Technical Service Information Bulletin

2.0 Rubber Hose STAUFF Clamps

Date: November 7, 2023 **Bulletin Name:** FDM-TSIB-047

Model: Oshkosh S-Series 2.0
Units Affected: Serial No. 788727 - 827508

Figure 1 - Power Chute STAUFF Clamps

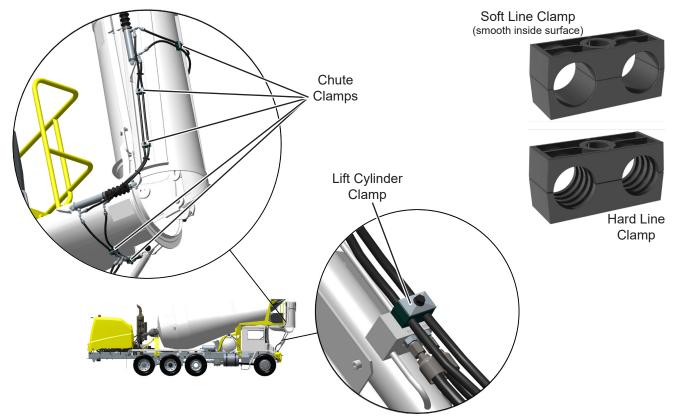
This bulletin provides instructions for installing rubber hose STAUFF clamps in areas of the vehicle that have hard line STAUFF clamps installed on rubber hoses. Rubber hose STAUFF clamps have a smooth inner contact surface and filleted edges. Installing rubber hose STAUFF clamps will reduce potential hose chaffing in areas where hard line clamps were installed.

3. Locate the 5 hard line STAUFF clamps on the power chute assembly first and second sections, and one on the lift cylinder. See Figure 1.

- 6. Remove clamp body from rubber hoses. Clamp body will not be reused.
- 7. Inspect rubber hoses for wear and replace as required.
- 8. Install new clamp body (A000G257) on rubber hoses.

- 9. Reinstall cover plate on clamp body.
- 10. Apply Loctite® 242 to threads of new hex flange screw (A000A519) and install in cover plate. See Figure 2. Final tighten mounting screw to 8 ft. lbs.

Figure 2 - STAUFF Clamp Assembly

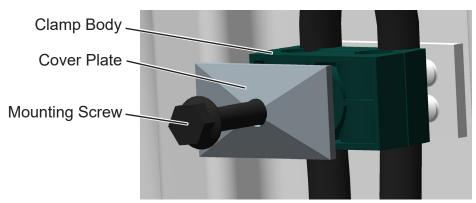
- 15. Install new clamp body (A000G257) on rubber hoses.
- 16. Reinstall cover plate on clamp body.
- 17. Apply Loctite® 242 to threads of new hex flange screw (A000A520) and install in cover plate. See Figure 2. Final tighten mounting screw to 13 ft. lbs.
